From: Donna Tisdale <tisdale.donna@gmail.com>
Sent: Sunday, March 02, 2014 8:19 PM
To: Hingtgen, Robert J; Fogg, Mindy; Gungle, Ashley
Subject: Soitec DPEIR errors & omissions
Attachments: Tisdale BPG Soitec DPEIR errors and omissions 3-2-14.docx

FOR THE SOITEC SOLAR DPEIR RECORD

Soitec Solar partial and incomplete list of errors, omissions (ran out of time for full review or proper organization and editing)

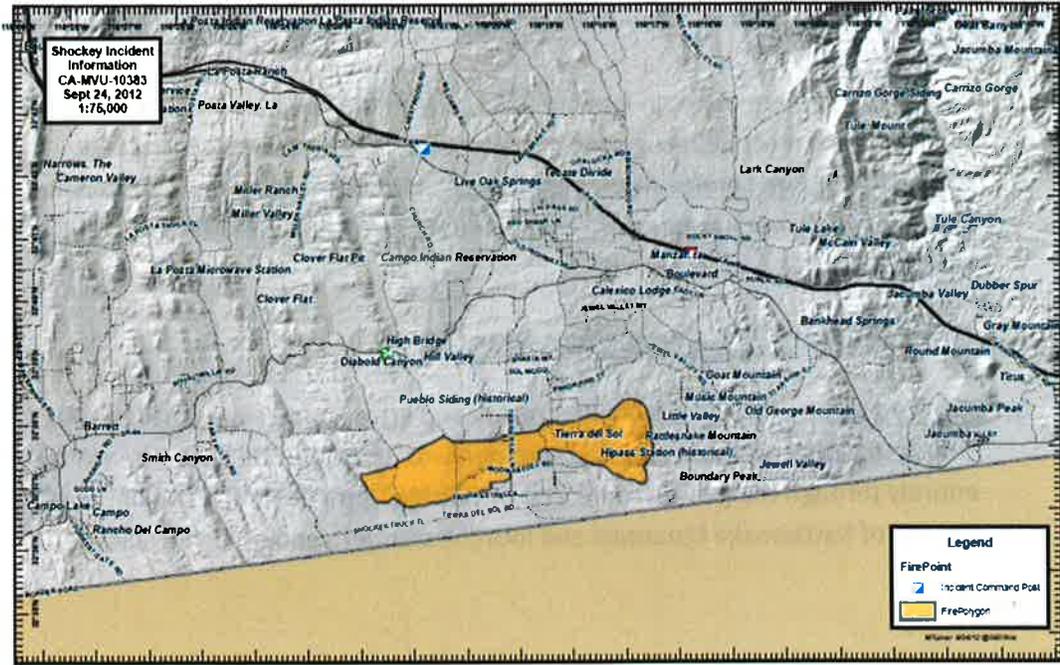
1. **@ page 22 of Emergency Service Capabilities Assessment¹⁰:**
 - 5th bullet point incorrectly states that the Shockey Fire burned a small portion of the western portion of the Tierra Del Sol Solar site while omitting the fact that the 2012 Shockey Fire (FM-5021) burned 2,556 acres of the Tierra Del Sol area, killed 1 resident, injured 3 firefighters, destroyed 14 homes, 14 outbuildings, 11 vehicles damaged 2 homes, and resulted in the shut-down of Tierra Del Sol Road for several days, the sole access road to the area that is under County jurisdiction.
 - The CalFire incident report¹¹ and map of the fire polygon (footprint pasted below)¹² provide accurate information that should have been included in the DPEIR
